ADDENDUM # 1

Project Name: DAS TMVC Floor Slab Repair

DAS# 9465.00

Dated: 03/27/2026

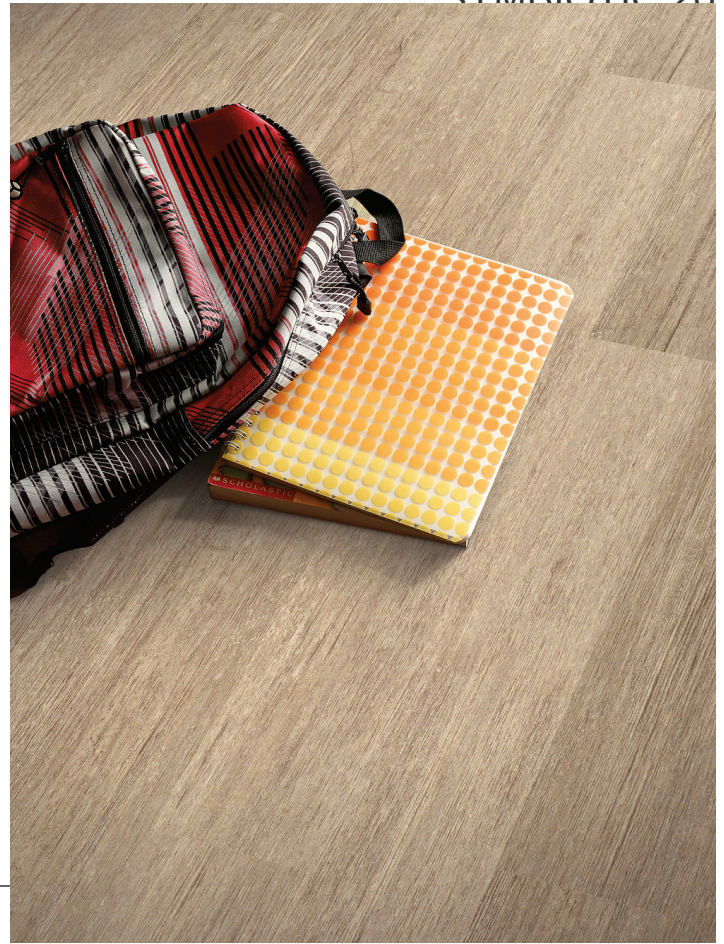
- a. *Substitution for LVT Symbiotic 20 5M303 is approved. Owner to select color from manufacturer's standard line.*

A-102

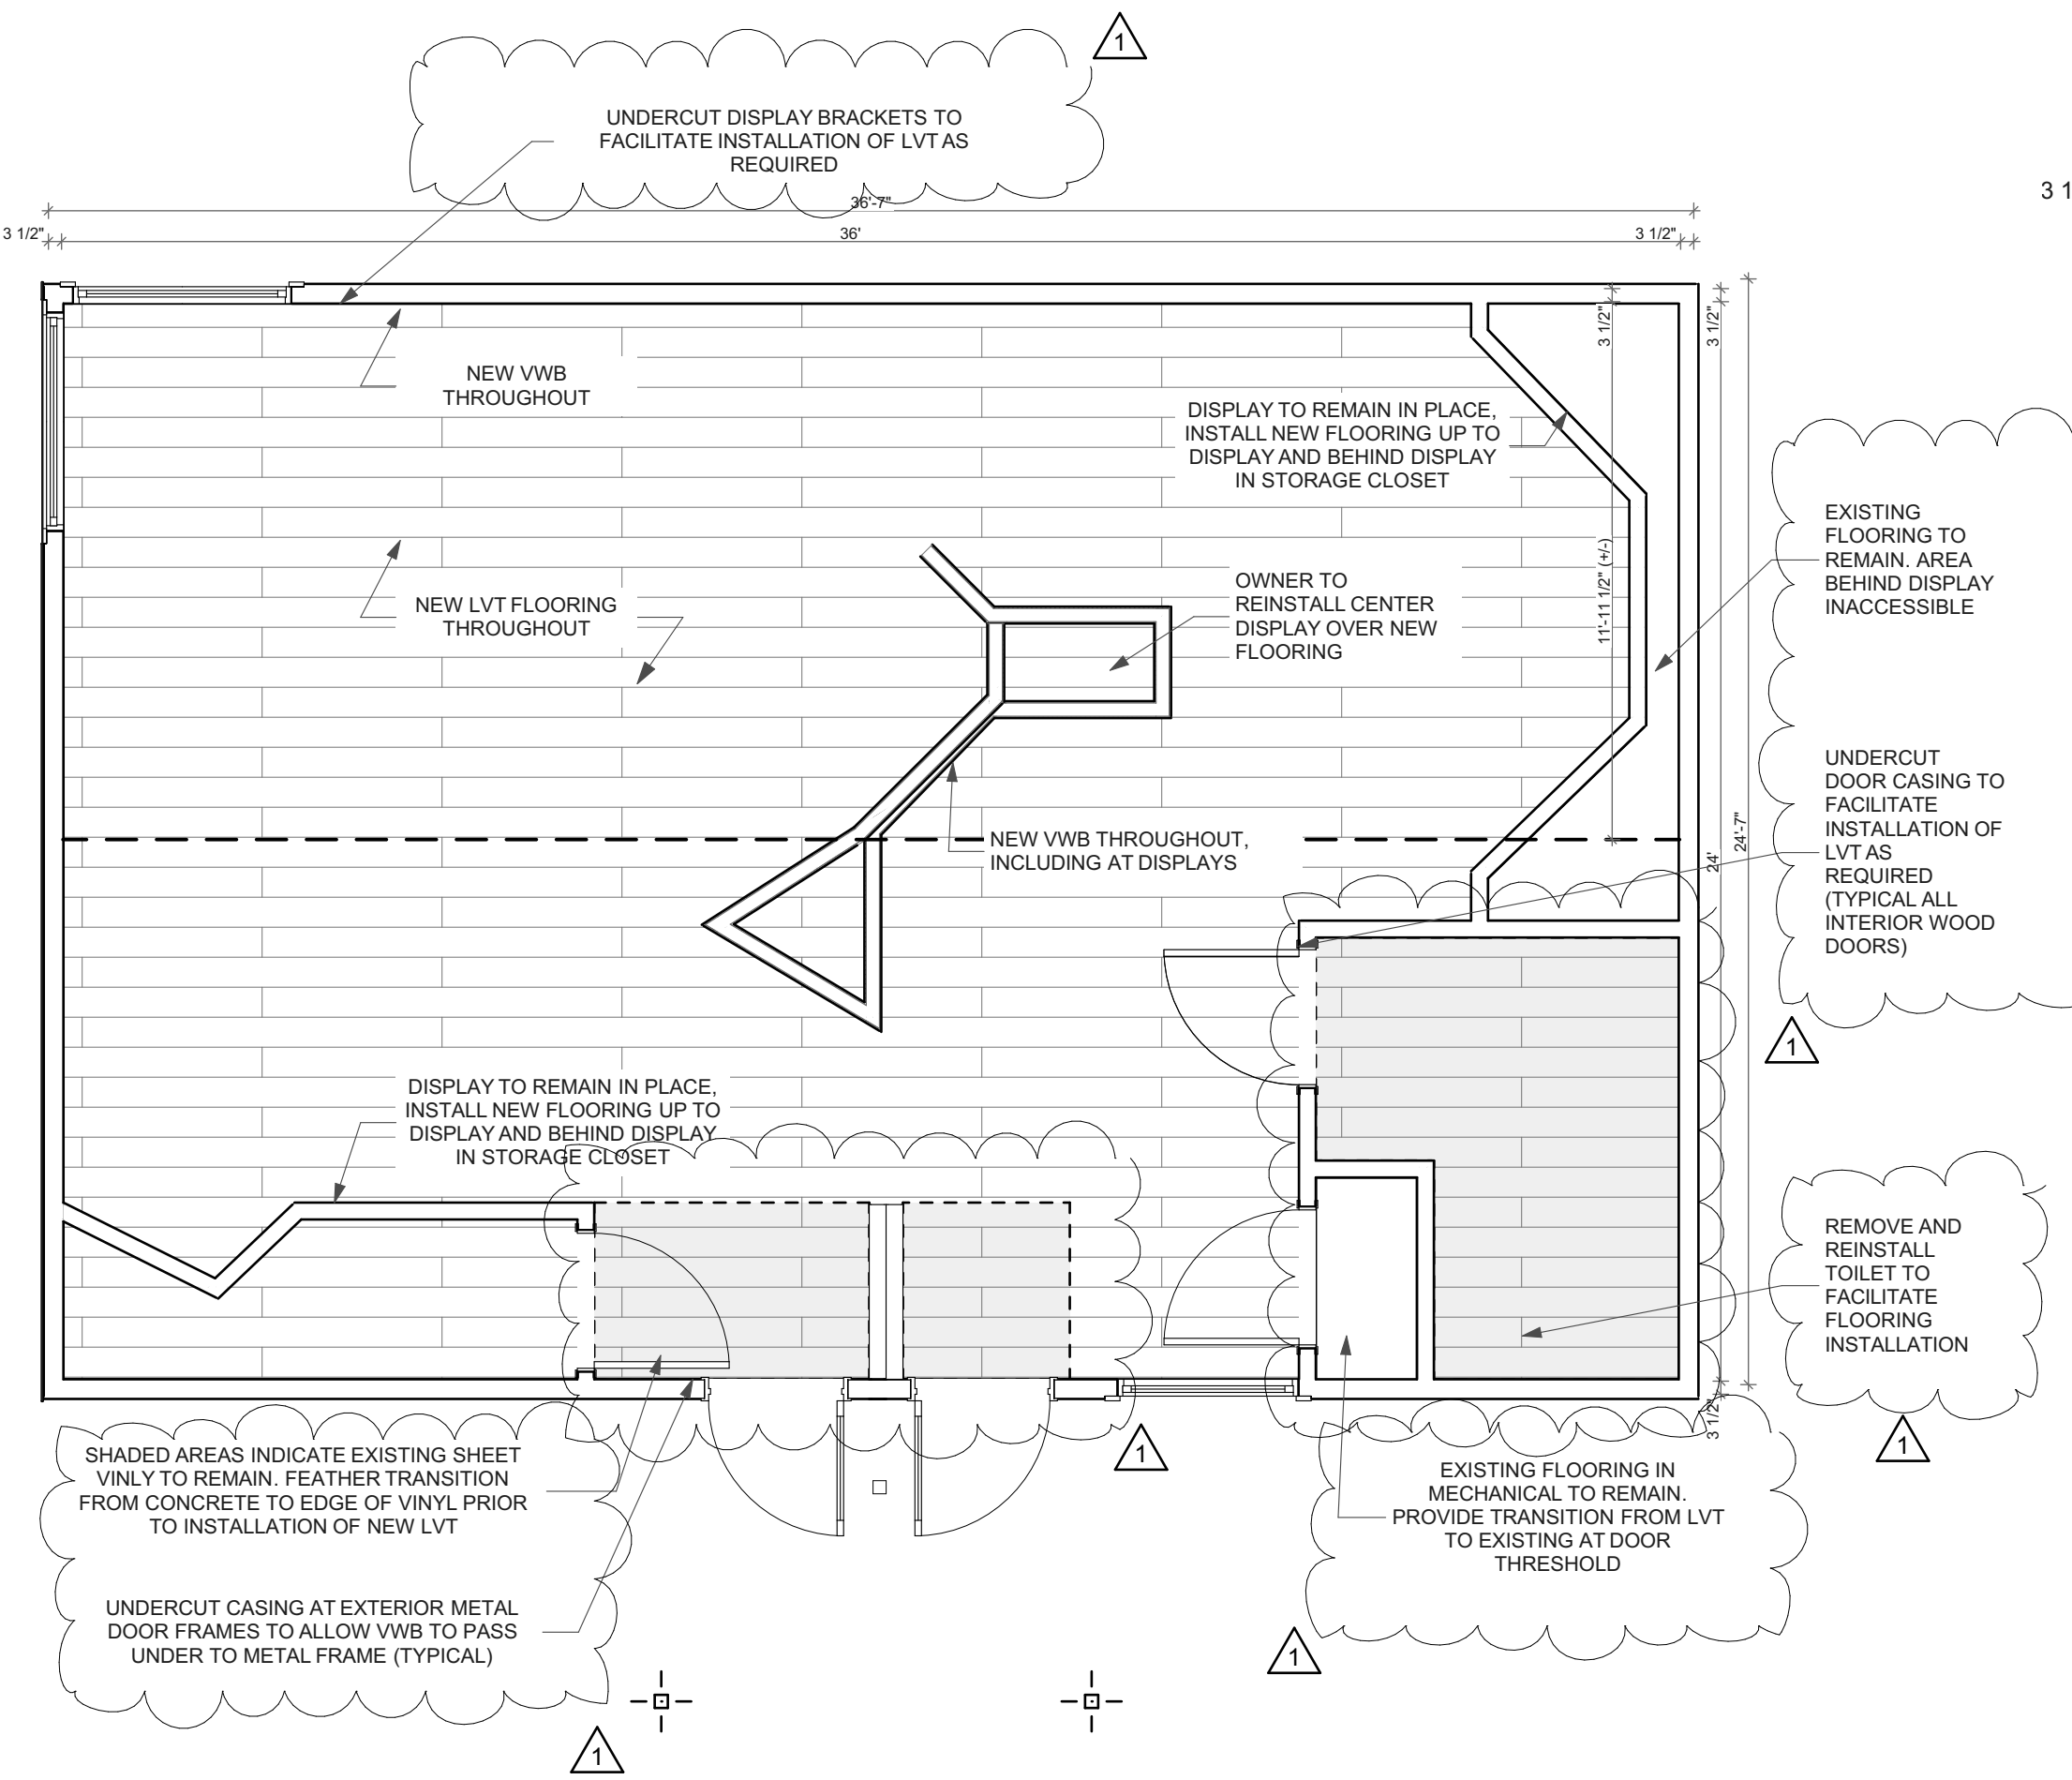
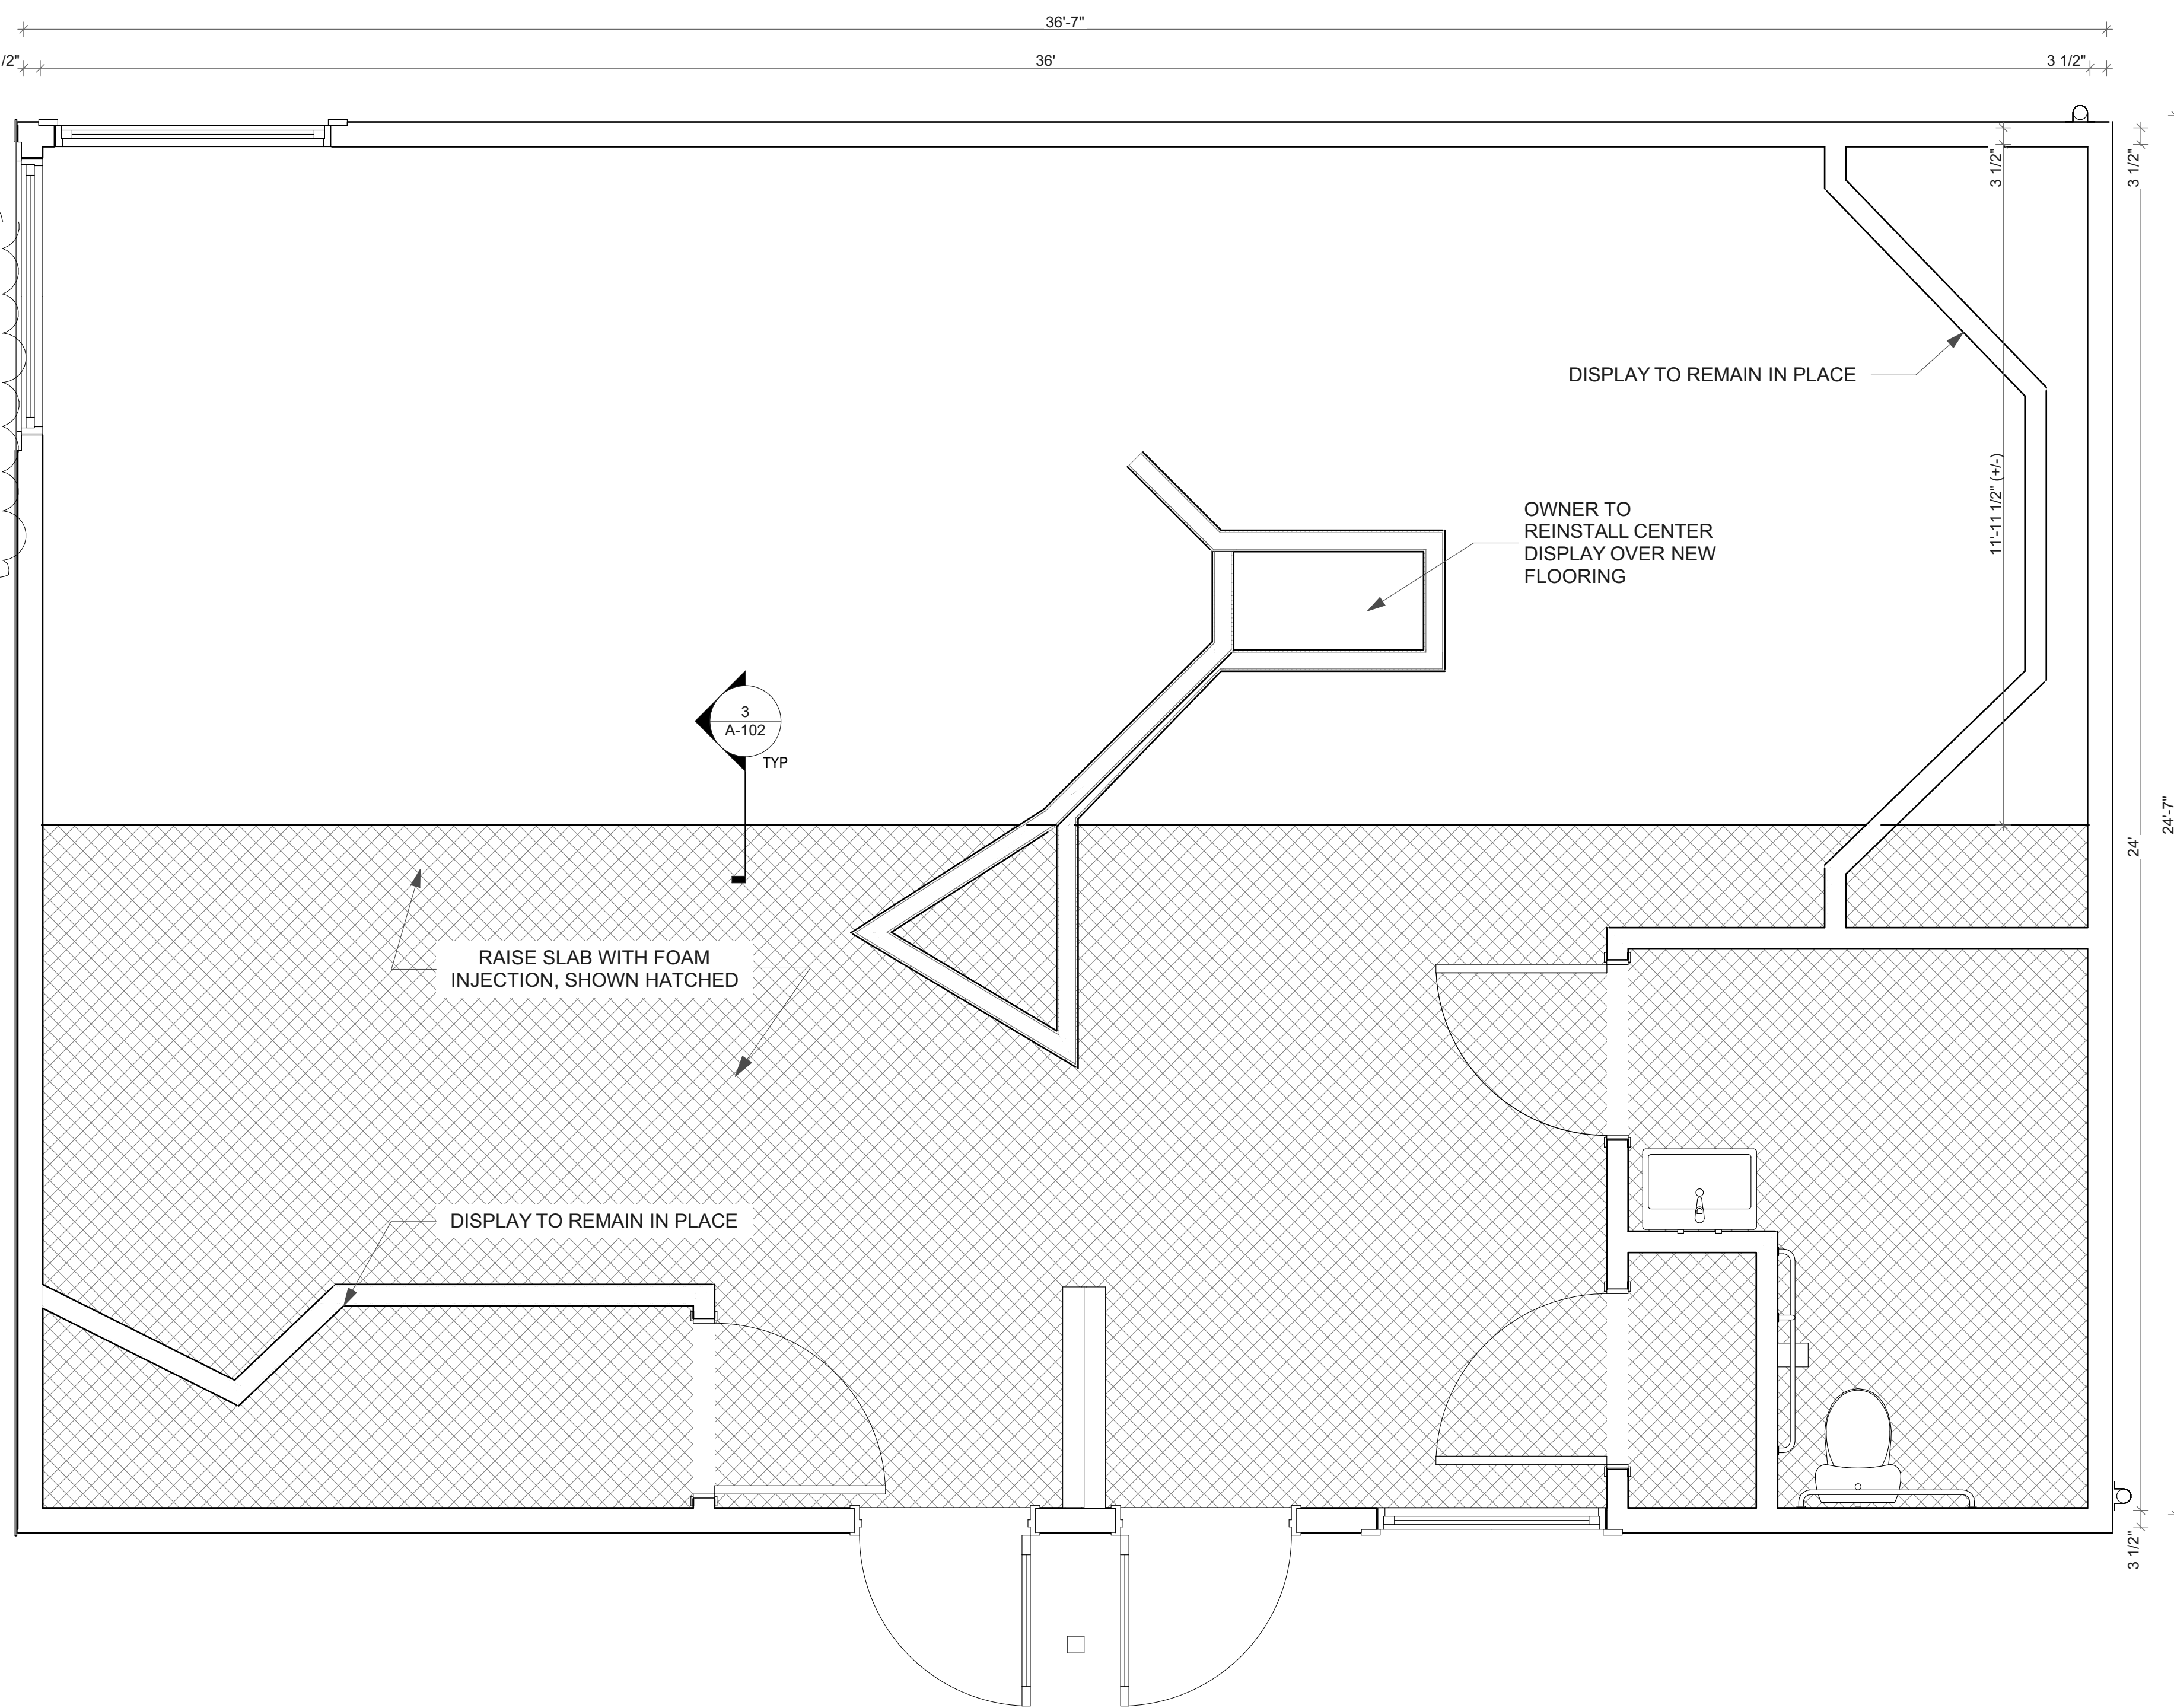
- a. *Drawing A-102 updated with additional notes.*
